Greater Cambridge Design Review Panel

Meeting Notes Confidential

Project name: The Beehive Centre redevelopment

Pre-Application Reference: 23/03204/OUT

Townscape and Heritage Enhancements
Coldhams Common B - Amended

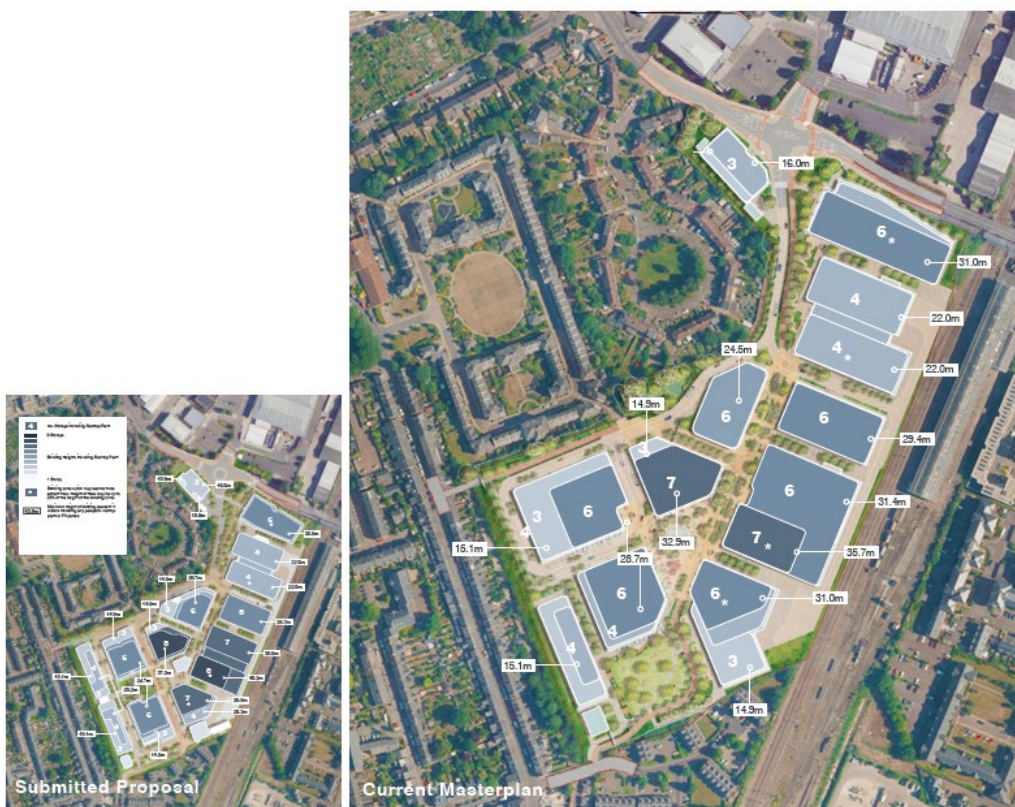
Plot 2 is highly visible in the views from Castle Hill Mound (p127) and Coldham's Common (p128) as it 'kick's up' at the end of the north-south sequence of massing. Plot 7's relationship with the adjacent housing has improved but could still move away from the boundary. Are there issues of overlooking from the roof terraces, as Plot 7, 9 and 6.
